Questions for Historic Commission regarding 4300 Ave D (Clark-Emmert):

4300 site plan

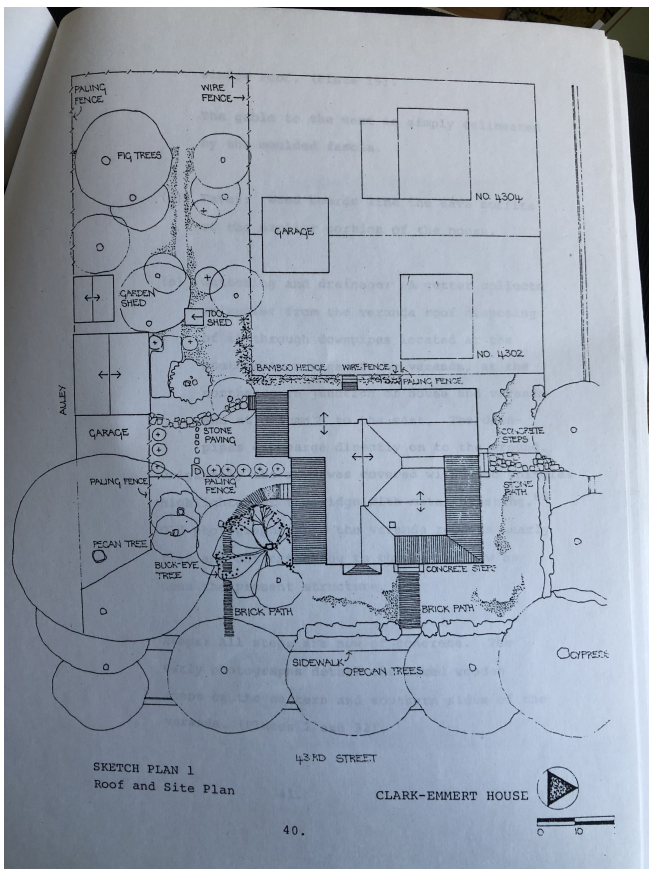
3. the remainder of the roof (12:12) will be shingled in a gray colored asphalt shingle
4. there are two doors that were not present when the house was constructed, that are currently unused/unusable:

- a) on the west side, facing the alley a door leads to the hallway containing the laundry. We have not opened as long as we’ve lived in the house.
 - b) on the north side facing 4302 Ave D is a door that is covered by plywood and drywall on the interior and is in the back of the pantry.

- c) We would like to remove both doors and concrete stoops and replace with either siding (north side) or a matching window (west side)
5. We plan to paint the house the original 1895 body color and the trim an off white with black accents (this is the current paint scheme)
